# Work Order ID 82211

Item Name: Crosstube Assembly, Mid Fwd

DRAWING NO. D206-667-147	TITLE CROSSTUBE ASS'Y (206L MID FWD)	REV. A	<b>DART AEROSPACE LTD ENGINEERING ORDER</b>		D.E.O. NO. D206-667-147-A-1	SHEET NO. SHEET 1 OF 1	SCALE NTS
DRAWN <i>Q</i>	CHECKED <i>ADS</i>	MFG. APPR. <i>JB</i>	APPROVED <i>MD</i>		DE APPR. <i>MD</i>		
DATE 11.07.15	DATE 11.07.20	DATE 11.07.21	DATE 11/07/21		DATE 11.07.21

**PURPOSE:**

<b>DART AEROSPACE LTD</b> HAWKESBURY, ONTARIO, CANADA	
DRAWING NO. D206-667-147	REV. A SHEET 1 OF 4
TITLE CROSSTUBE ASS'Y (206L MID FWD)	SCALE NTS

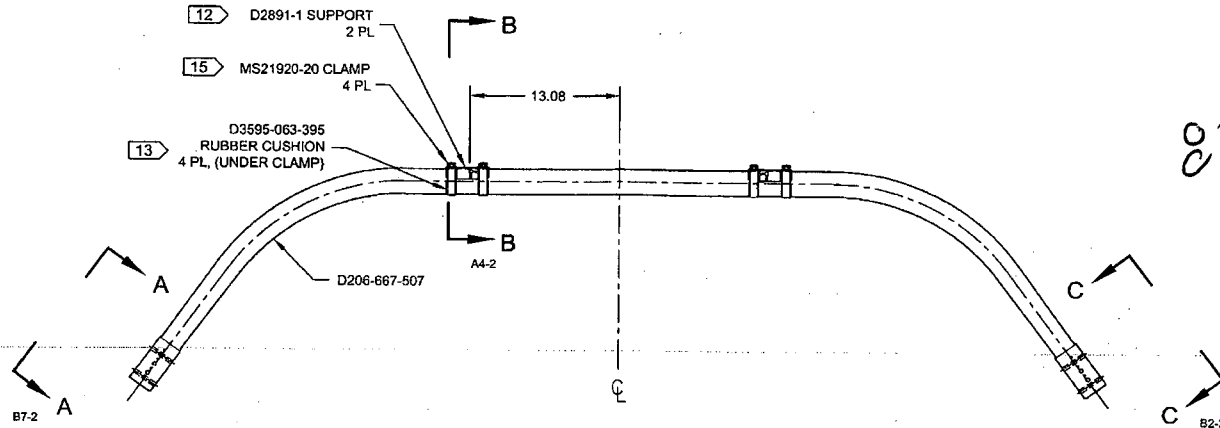
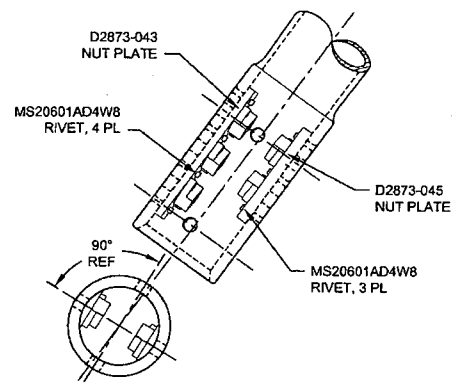
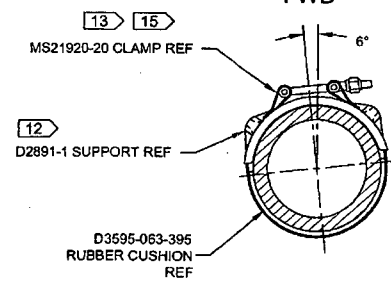
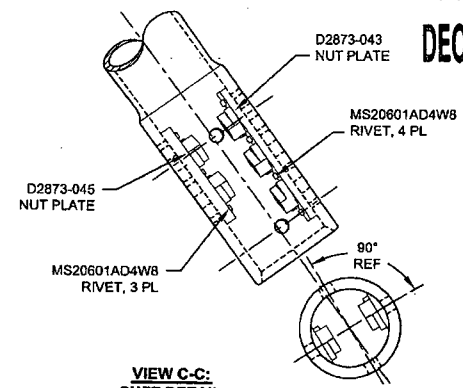
REPLACE MAGNOBOND WITH PROSEAL.

NOTE 12 & 15, SHEET 1 IS AMENDED AS FOLLOWS:

- 12) INSTALL D2891-1 SUPPORT USING 0.03" TO 0.06" THICK LAYER OF MAGNOBOND 6398 PER QSI 015. LET CURE FOR 12 HOURS AFTER INSTALLATION AND PRIOR TO PACKAGING.
- 15) TORQUE CLAMPS 80 TO 100 IN-LB. ENSURE AT LEAST 1.5 THREADS SHOWING IN SAFETY AND THAT NUT HAS NOT BOTTOMED-OUT AFTER TORQUING.

- 12) TO INSTALL D2891-1 SUPPORT: ABRASE MATING SURFACE OF SUPPORT AND CROSSTUBE WITH 180-GRIT SANDPAPER AND REMOVE RESIDUE WITH MEK (OR EQUIVALENT). APPLY A 0.04" TO 0.07" THICK LAYER OF PROSEAL 890 CLASS B-2 (OR AMS-S-8802 CLASS B-2) SEALANT TO MATING SURFACE OF SUPPORT.
- 15) TORQUE CLAMPS 80 TO 100 IN-LB. ENSURE AT LEAST 1.5 THREADS SHOWING IN SAFETY AND THAT NUT HAS NOT BOTTOMED-OUT AFTER TORQUING. **PRIOR TO PACKAGING, RE-CHECK TORQUE ON CLAMPS AFTER PROSEAL 890 SEALANT HAS CURED FOR 72 HOURS.**
